## BUILDING NO. 2 DRIVE THROUGH AT NOVI TOWN CENTER JSP17-08

Public hearing at the request of Novi Town Center Investors, LLC for Building No. 2 Drive Through at Novi Town Center JSP 17-08, for Planning Commission's recommendation to the City Council for approval of Special Land Use Permit, Preliminary Site Plan and Storm Water Management Plan. The subject property is zoned Town Center District (TC). It is located in Novi Town Center in Section 14, on the northeast corner of Grand River Avenue and Novi Road. The applicant is proposing to reconstruct the existing parking lot on the southwest end of Novi Town Center in order to construct a drive-through lane for a future coffee shop. A 48 square foot addition along with outdoor seating is also proposed. A Special Land Use Permit is required in order to permit Drive-Through restaurants in the TC Town Center District.

# PLAN REVIEW CENTER REPORT

Preliminary and Final Site Plan and Stormwater Management Plan

ORIGINAL ISSUE DATE: APRIL 7, 2017  
 PEA JOB NO. 2017-044  
 SCALE: 1" = 20'  
 DRAWING NUMBER: C-4

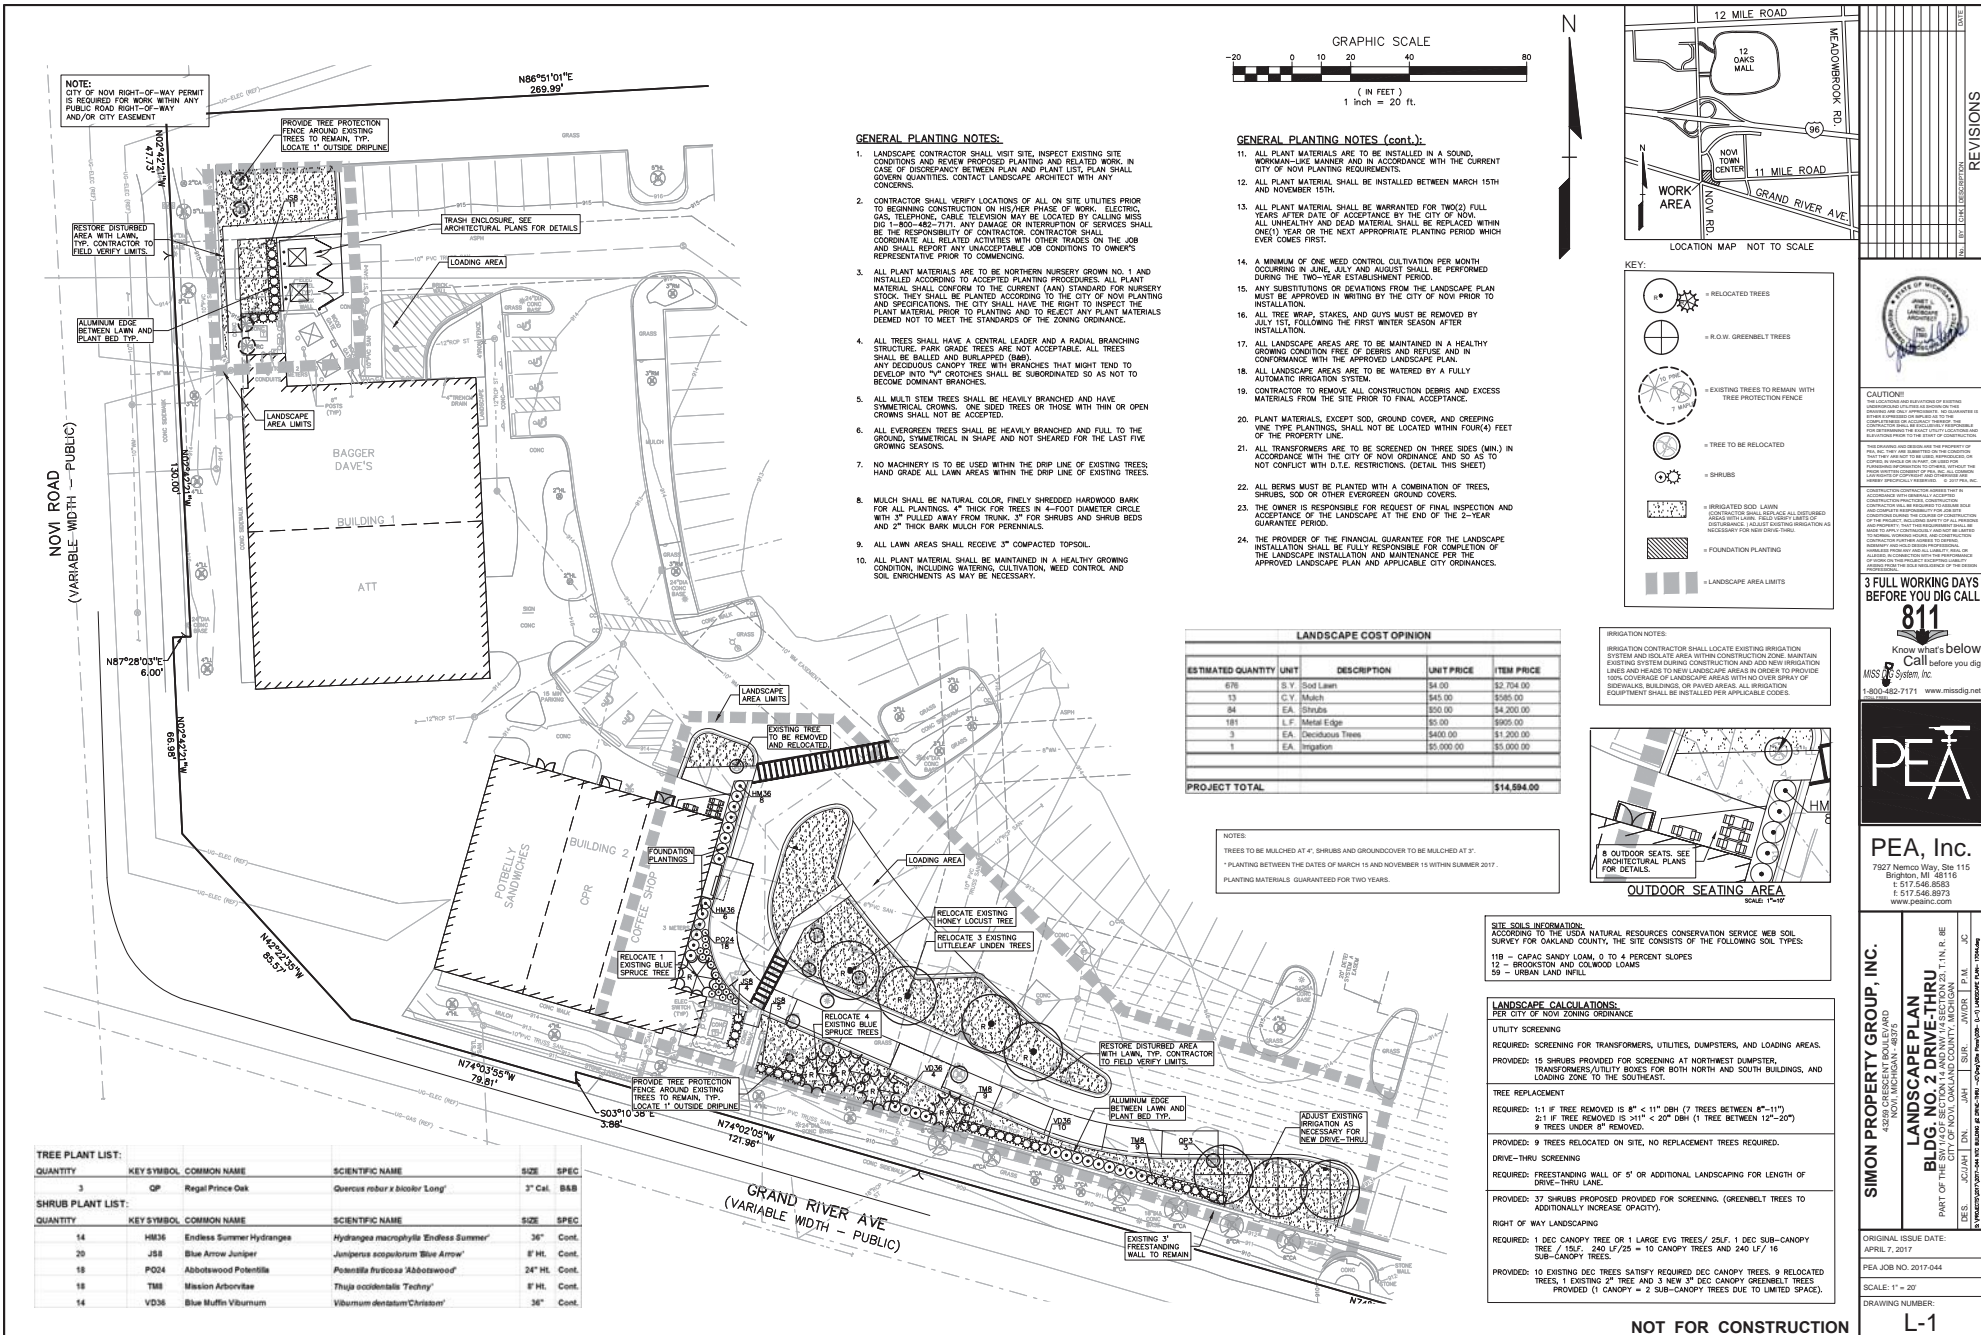
1. Sheet C-4: Locate the proposed drive-thru menu board outside of the existing sanitary sewer easement. Show a portion of said easement on the same plan sheet as a reference relative to the menu board location.

2. **Sheet C-4: Locate the proposed trash enclosure wall foundation outside of the existing sanitary sewer easement. Show a portion of said easement on the same plan sheet as a reference relative to the trash enclosure wall location.**

**From:** Matt Niles [mailto:mniles@wahyeeassoc.com]  
**Sent:** Monday, May 01, 2017 4:10 PM  
**To:** Komaragiri, Sri  
**Cc:** JClear@simon.com; Jon Curry; Jacob Holda; CFOSSE@WAHYEEASSOC.COM  
**Subject:** Drive-Thru Window At Novi T.C. : Dumpster Enclosure Wall Proposal

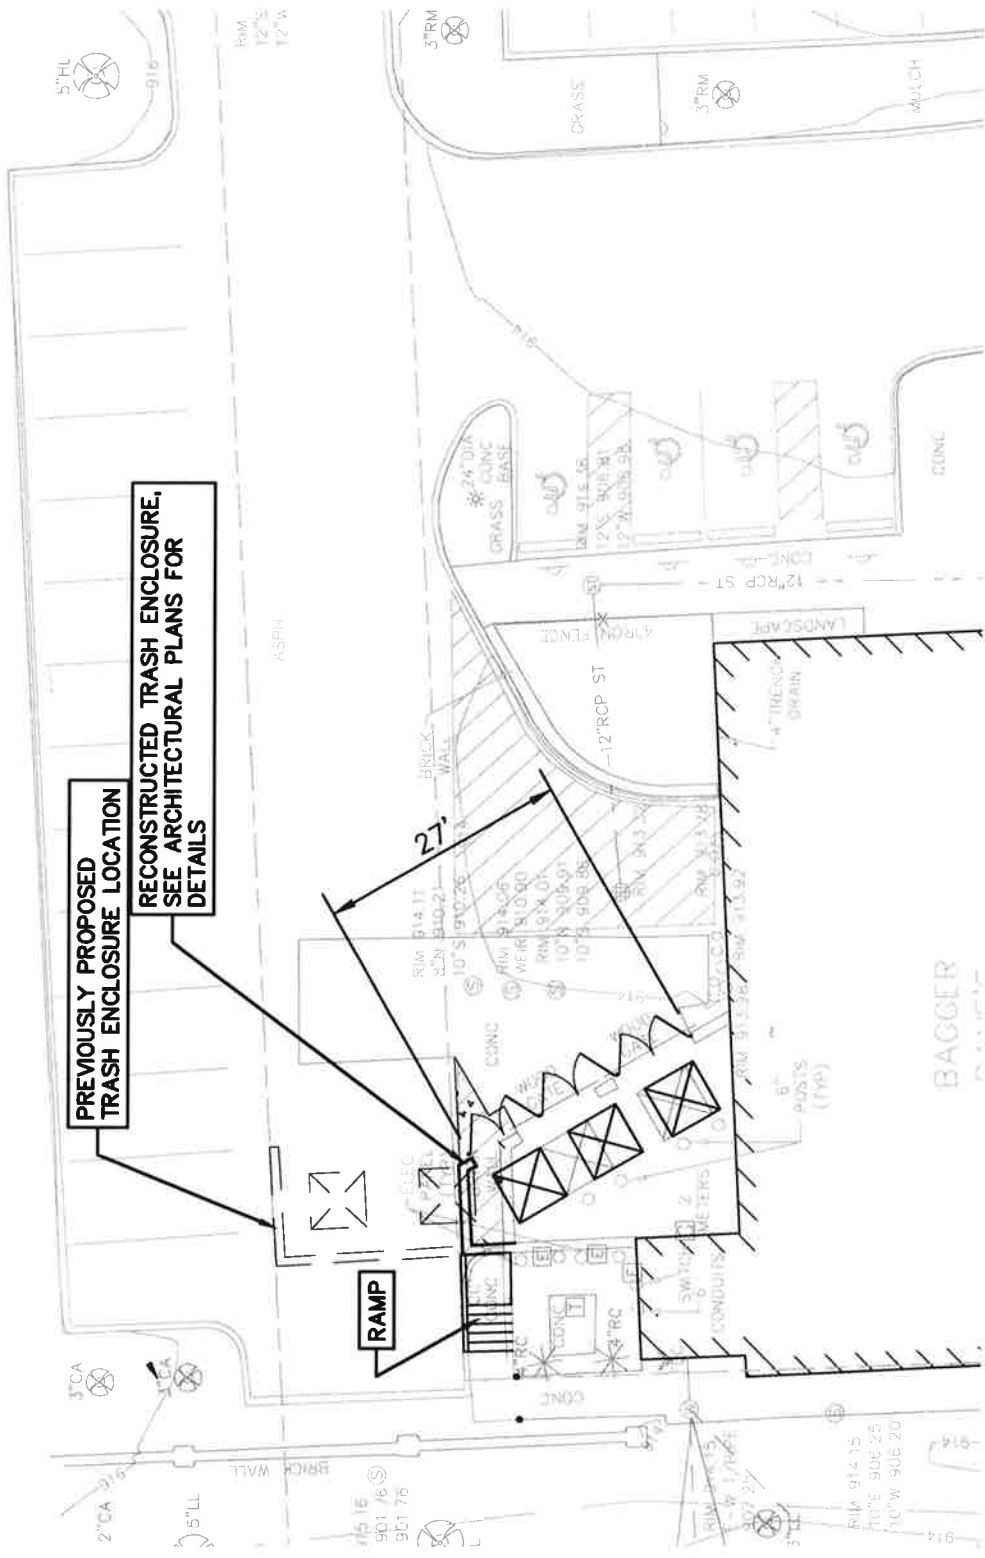
1. Noise Impact Statement:
2. Dumpster Location: **The proposed dumpster location conflicts with the parking spaces and sanitary sewer easement. Refer to Engineering and Traffic review for more details**
3. Plan Review Chart: **Refer to other minor comments in Plan Review Chart for more information requested with the electronic stamping set**

Attached is our proposal for resolving the issues with the new dumpster enclosure. Instead of building a new structure, we propose to just expand the existing enclosure a little to the north to accommodate one more dumpster. This should eliminate the conflict between parked cars and a truck servicing the dumpsters, but we can add the note designating these spaces as "employee spaces" if you still think that is needed. This also gets the enclosure off of the 10" sanitary easement. In this option, there will be one less dumpster than previously proposed, but we can resolve this by having the dumpsters serviced a little more often as needed. This proposal is actually much better than before as the overall dumpster enclosure will be smaller. Please see the attached plan. I would like to talk to you still today if possible to make sure that we will still be on the May 24<sup>th</sup> Planning Commission, and if there is anything else that you will need from us such as a revised submittal plan and or elevations incorporating this.
